ITEM NO.	MATERIAL	1GA24FJ24	1G24	1F40000-2424-S	210204-24S
		AEROQUIP PART NUMBER	① SOCKET	② NIPPLE	③ NUT
LIST OF MATERIALS					
		DRAWN J. HUFFMAN CHECKED R. GARRETT APPROVED R. GARRETT RELEASE DATE 3-29-95			
		EN-F15568 DP-24900			
		SIZE C DRAWING NUMBER 1GA24FJ24		REV B	
		SCALE 1/1 DIST U		CAGE CODE 01276 SHEET NO

DWG. NO. 1GA24FJ24 SH. REV. B

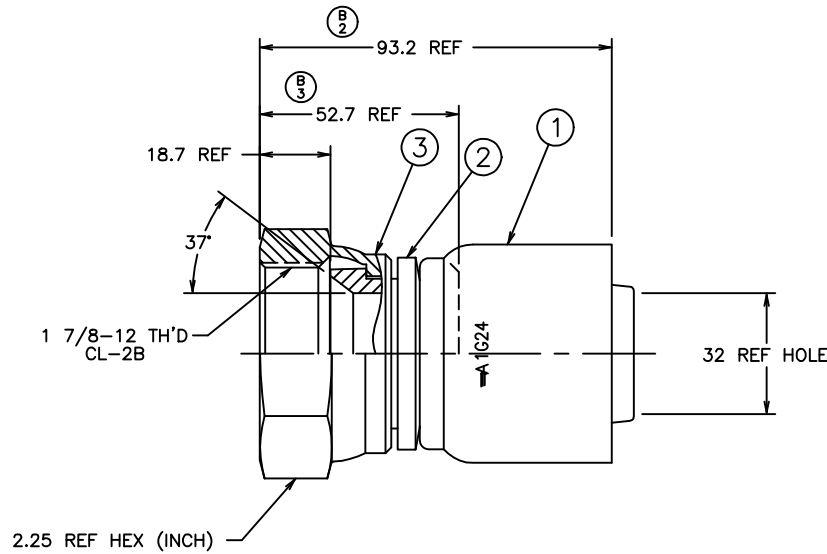
REV	DESCRIPTION	DATE	APPROVED
B	REDRAWN - SUPERSEDES 1GA_FJ_SHEET 2, REV "A" FOR 1GA24FJ24 (1) NOTE # 1(g) WAS: "CRIMP NUT PER ACES 2409P2" (2) 93.2 REF WAS 93.7 REF (3) 52.7 REF WAS 52.6 REF	3-20-95	EN-F15568 DP-24900

- (a) CRIMP NUT PER ACES 2813.
- (b) ASSEMBLE SOCKET PER ACES 2813.
